## PROFILES

SITE DEVELOPMENT PLAN FOR  
DAVITA KIDNEY CARE  
PREPARED FOR  
TIMBERBROOK ASSOCIATES, LLC  
AMSTERDAM MAGISTERIAL DISTRICT  
BOTETOURT COUNTY, VIRGINIA

DATE:	November 8, 2017
SCALE:	1" = 20'(H), 1" = 10'(V)
COMMISSION NO.	17-078
SHEET	5 OF 10

STORM DRAIN PROFILE  
1" = 20' HOR. 10' VERT.STORM DRAIN PROFILE  
1" = 20' HOR. 10' VERT.STORM DRAIN PROFILE  
1" = 20' HOR. 10' VERT.ENTRANCE PROFILE  
1" = 20' HOR. 10' VERT.WATER LINE PROFILE  
1" = 20' HOR. 10' VERT.SEWER LATERAL PROFILE  
1" = 20' HOR. 10' VERT.

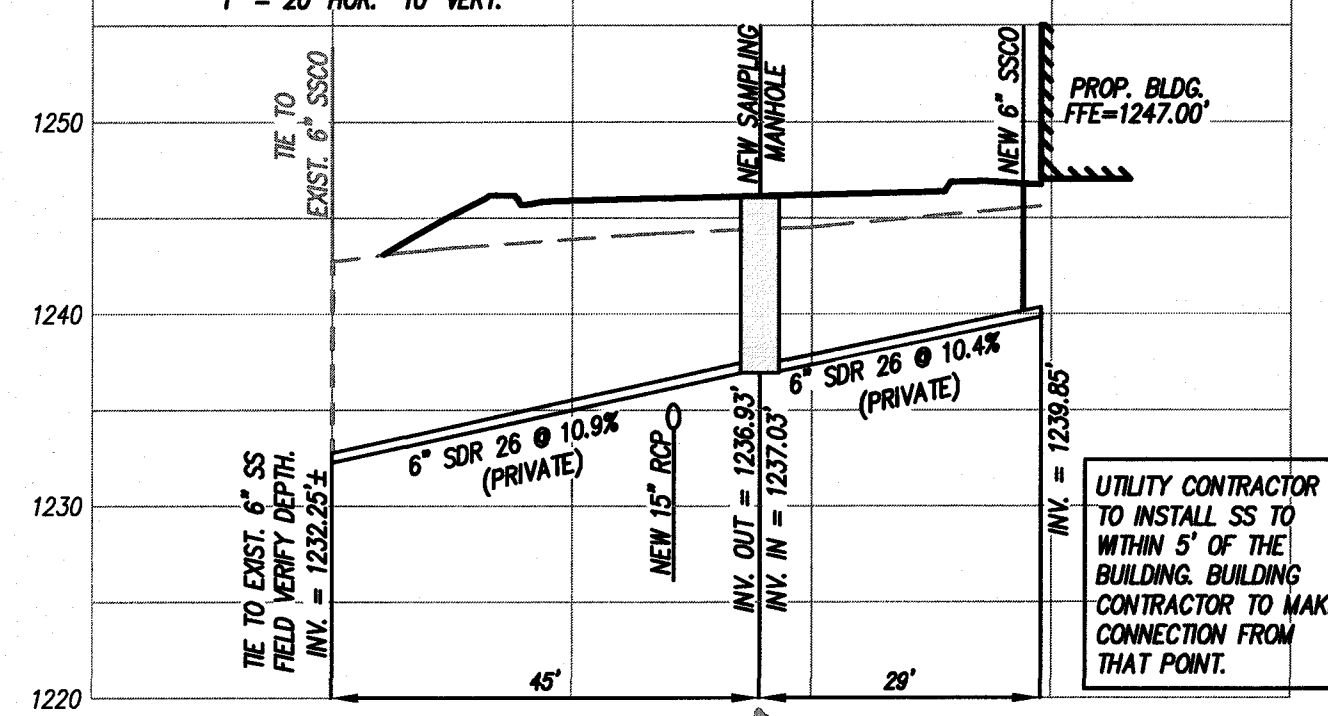
SAMPLING SSMH IS 9.10'DEEP  
C51 4' DIAMETER PRE-CAST  
U.S. FOUNDARY FRAME AND COVER  
VACUUM TESTED 12-12-17. PASSED.
